N1092A-05

Information Only Service Note

N1092A DCA-M Sampling Oscilloscope

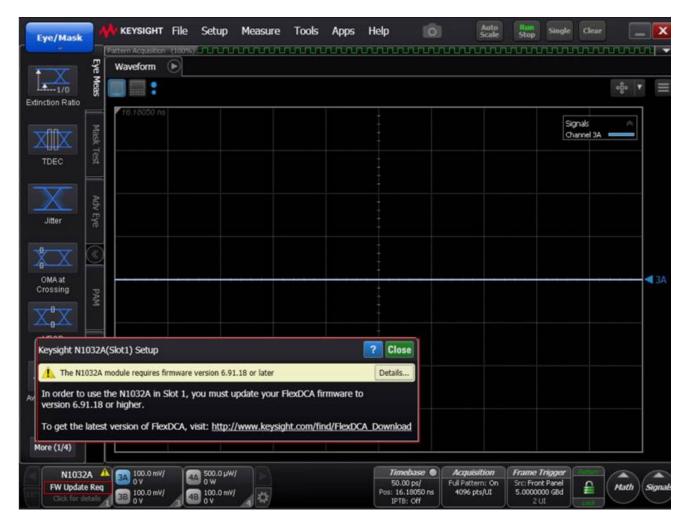
A message will be displayed in FlexDCA if a newer version is required.

With the instrument connected to FlexDCA, if a message like the one below is displayed, FlexDCA must be updated to the indicated version (or later):

To update FlexDCA software, download from <u>www.keysight.com/find/flexdca_download</u> and install. While only the indicated version is required, updating to the latest version is recommended.
